RE: Notice to Bidders
Great Rivers Greenway District
Centennial Greenway Phase IIA
Federal Project Number: TAP-9900(677)
Burns & McDonnell Project Number: 85395
Addendum Number 03

Organizations intending to submit a bid on Centennial Greenway Phase IIA are hereby advised of the following additions and modifications to the bidding documents:

Figure 1: Plan view from MoDOT standard drawing 203.62

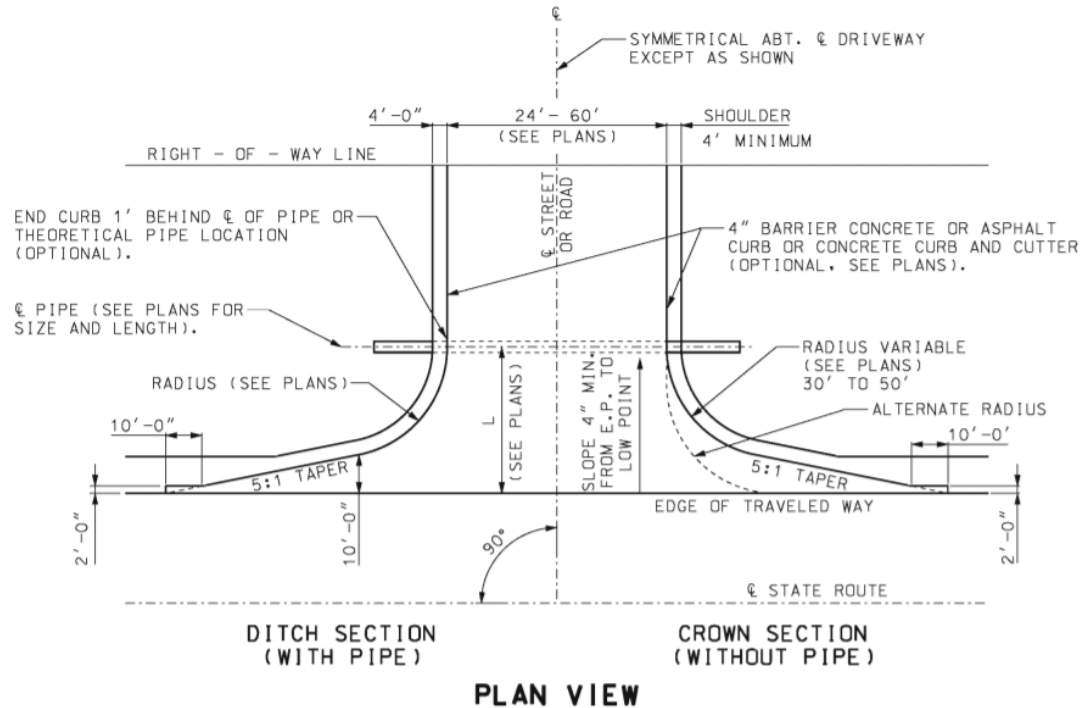
- e. **Question** – Item 94 – Temporary Contractor Access – JSP 76 states this is for commercial entrances at locations not shown on plans, which we interpret to mean at locations that we deem necessary for construction. However, the JSP goes on to state that the Engineer will give us the design for such entrances, yet we assume all costs. It would seem that this should either be a unit price or design provided prior to bid, as well as a quantity, so that contractor and engineer are on the same page prior to bid. Otherwise, contractor may assume a design far less involved than what engineer will produce after bid.

Answer – Replace the word “Commercial Entrances” with “Temporary Construction Access Points” in JSP 76.

Design is provided prior to bid. Utilize MoDOT standard plan 203.62 available at: http://www.modot.org/business/standards_and_specs/documents/20362.pdf. Minimum access point width shall be 24-feet and radius to be 30-feet with 5:1 taper. Utilize 18-inch corrugated metal pipe, Contractor to determine length of this pipe. Other items that are incidental to this bid item are listed in JSP 76. Surfacing for temporary entrance shall be a minimum 6-inches Type 5 Aggregate Base.

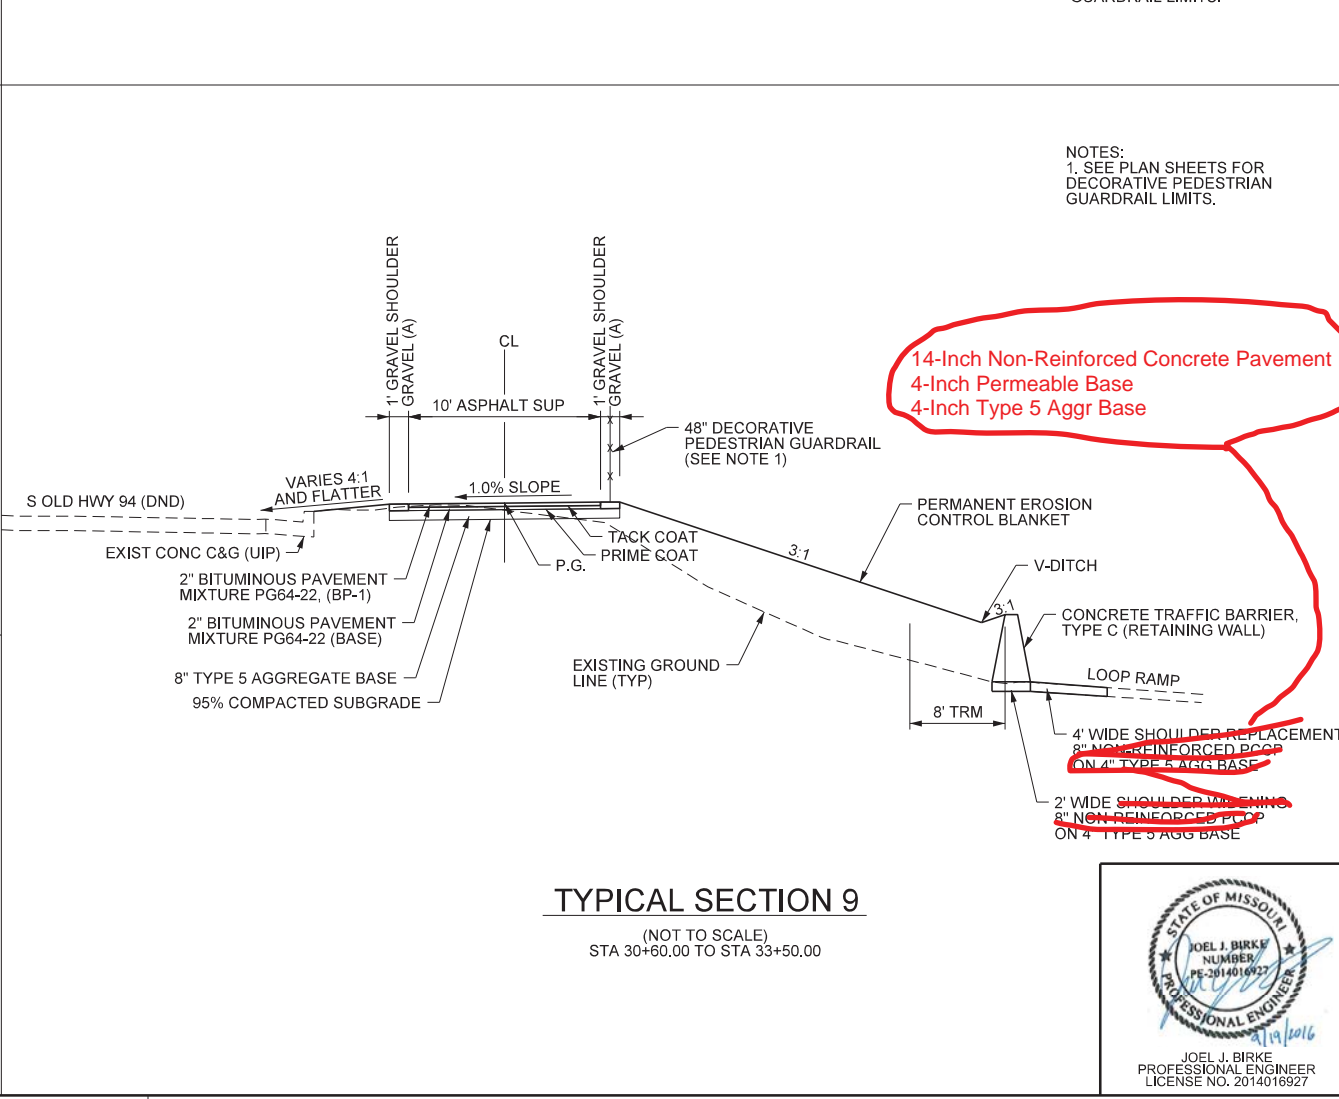
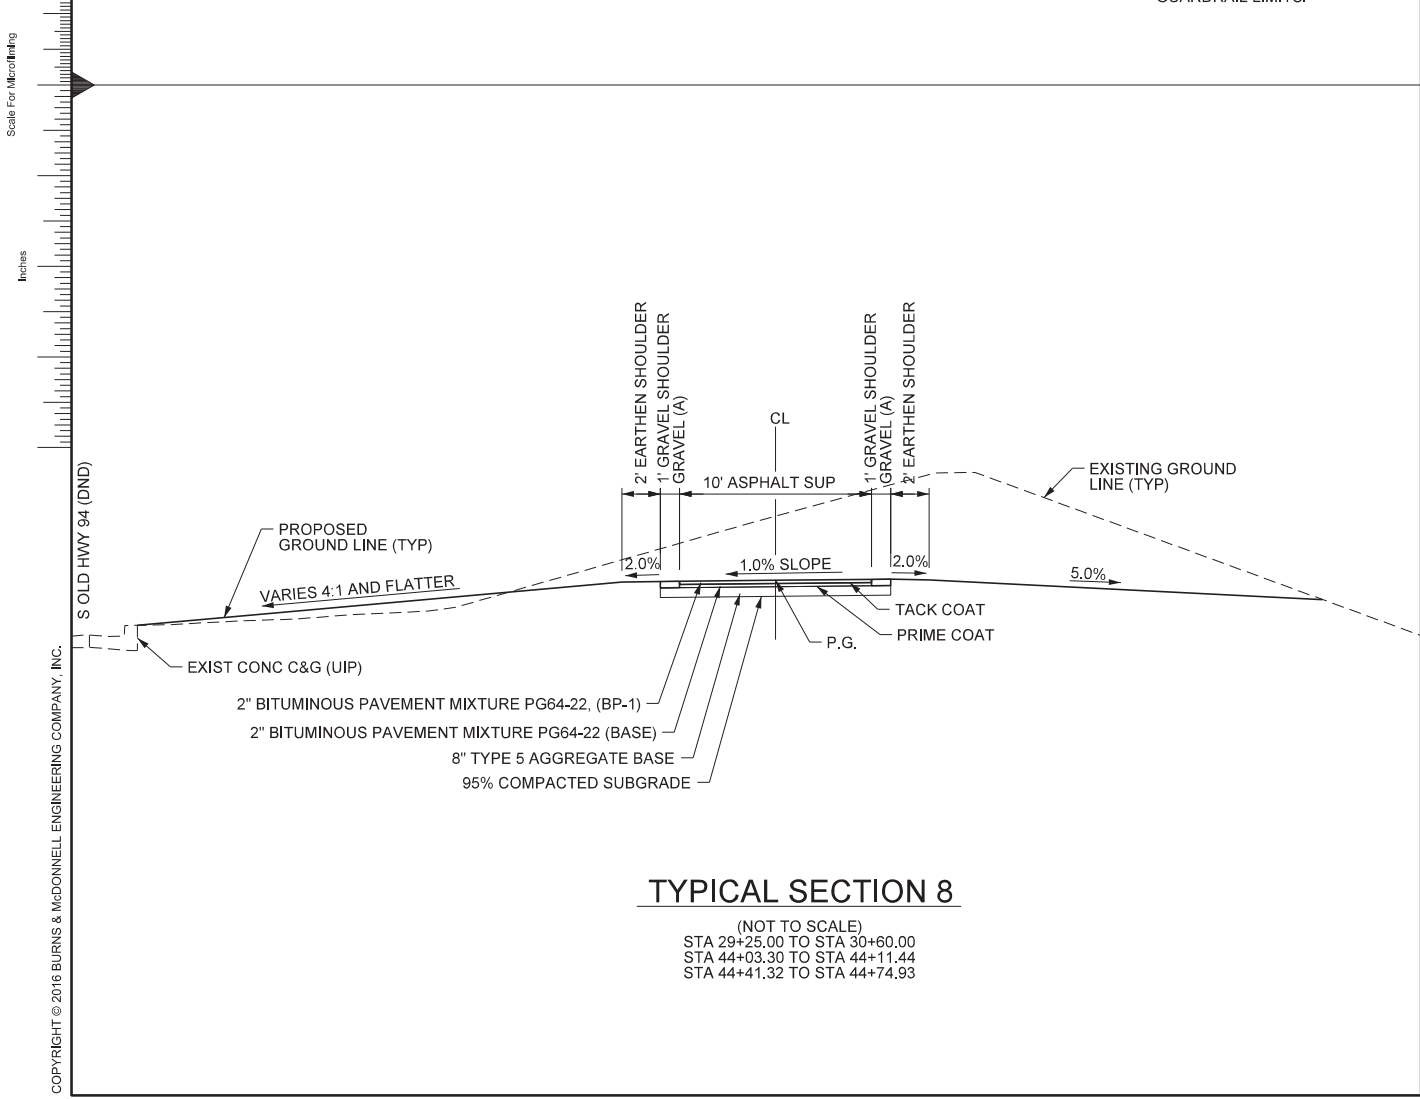
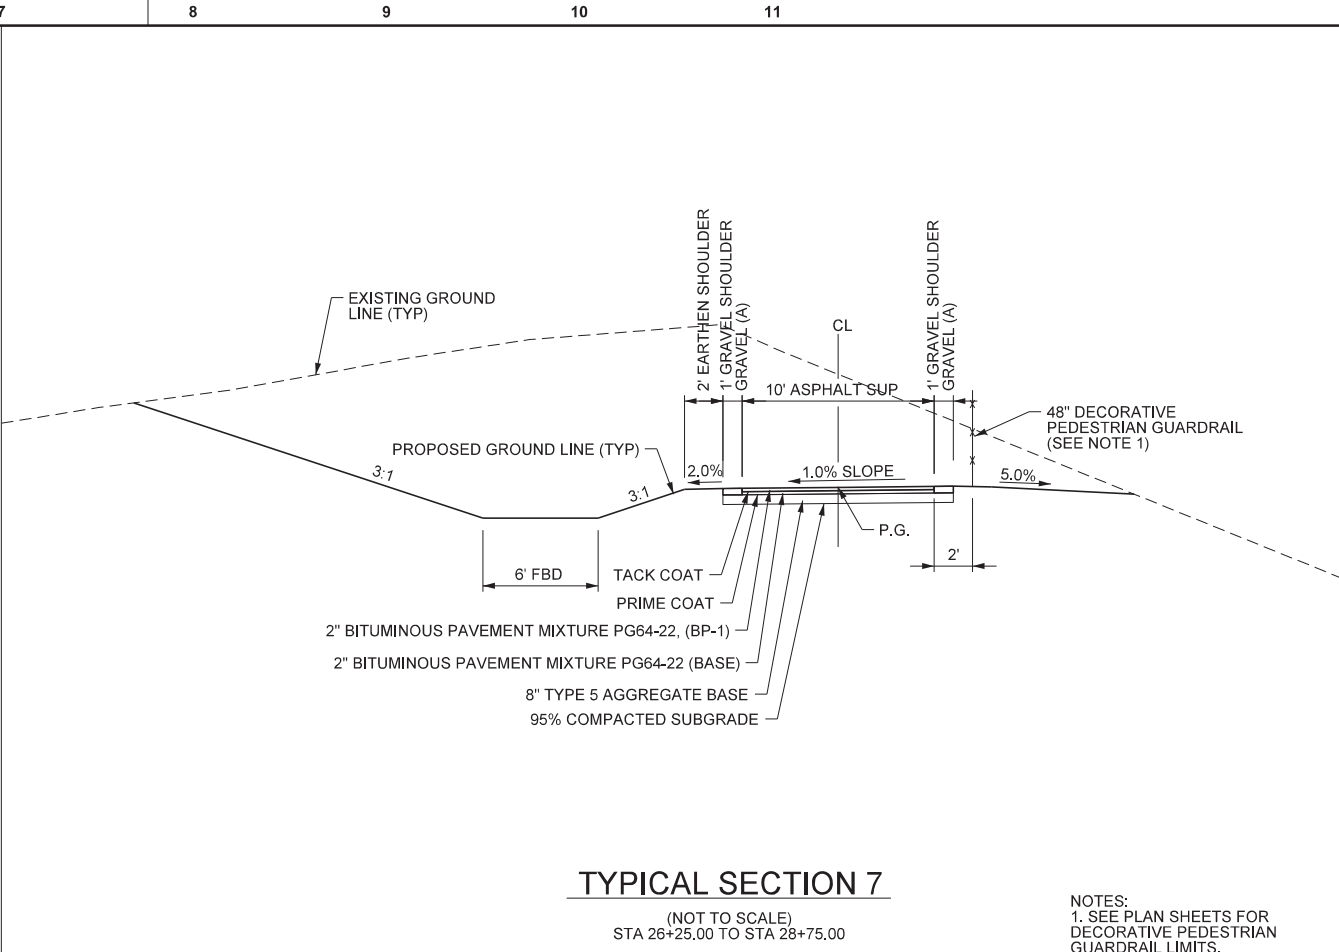
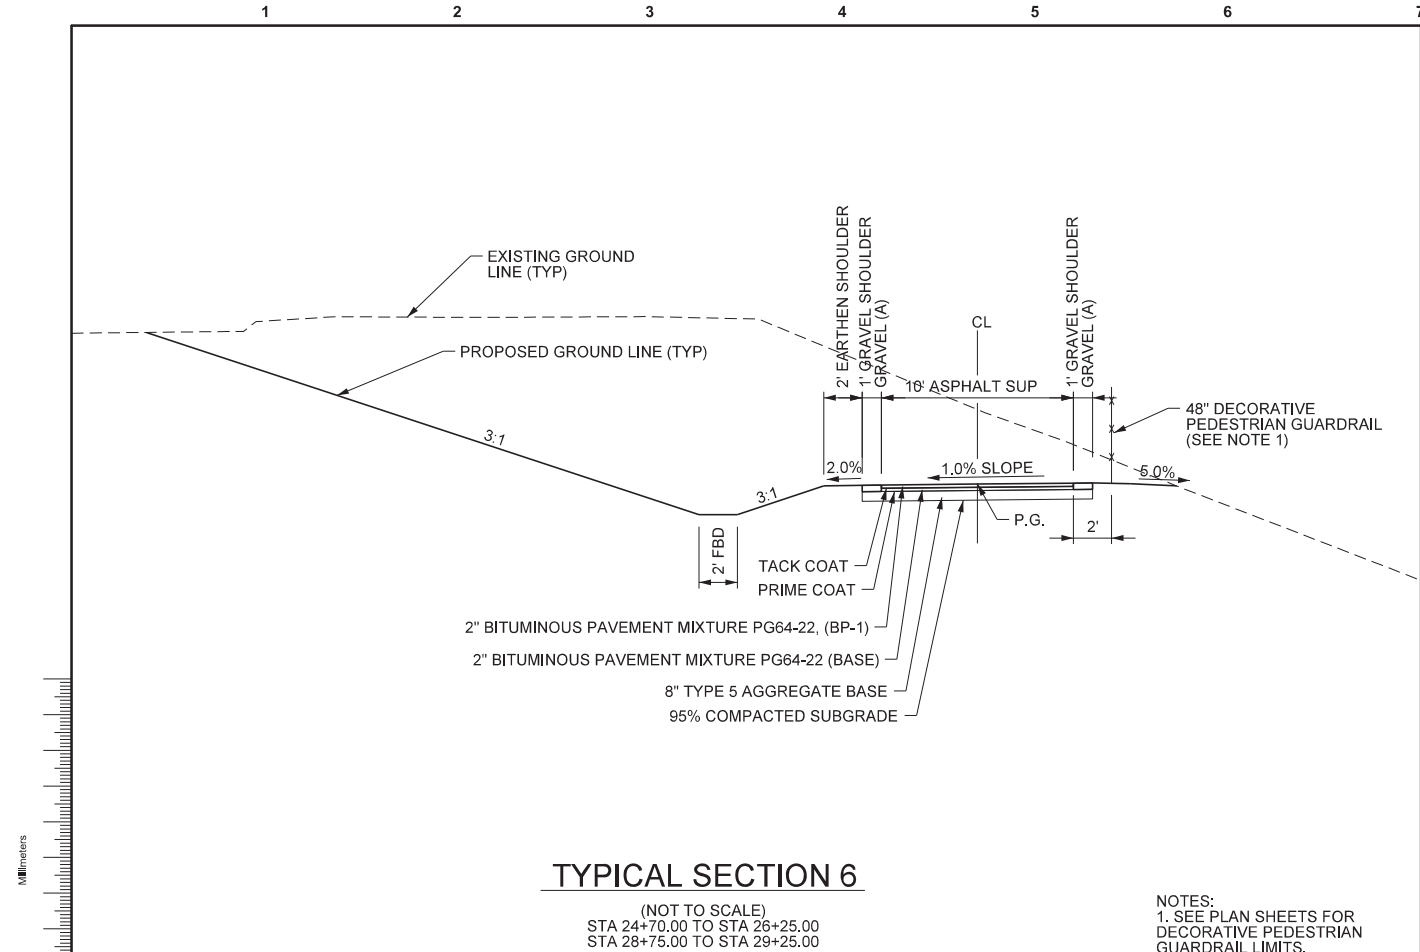
- a. **Question** - *Plan Sheet 2B-1, Concrete Pavement (8" Non-Reinf) has a quantity of 195 sy on Sheet L-102 and 162 sy. Is this a duplicate of the same area?*

- b. **Question** - *The drainage items (MSD Area Inlet, 12" Class III RCP, and 12" FES) listed on Plans Sheet 2B-5 for Add Alternate 2 are duplicated on plan sheet 2B-3 for the base bid items.*

Concrete Pavement – Sheet 2B-1 notes 492 SY on C-101. C-101 shows 565 SY (10 + 124 + 88 + 343)

Answer – *162 square yards is the quantity of 8" Non-Reinforced concrete pavement. Changes made to sheets 2B-1 and 2B-5, see attached.*

Answer – *The duplicate quantities of three items (MSD Area Inlet, 12" Class III RCP, and 12" FES) for Add Alternate 2 have been removed from sheet 2B-5, see attached.*

Answer – The quantity shall be 565 square yards. See attached revised 2B-1 sheet.
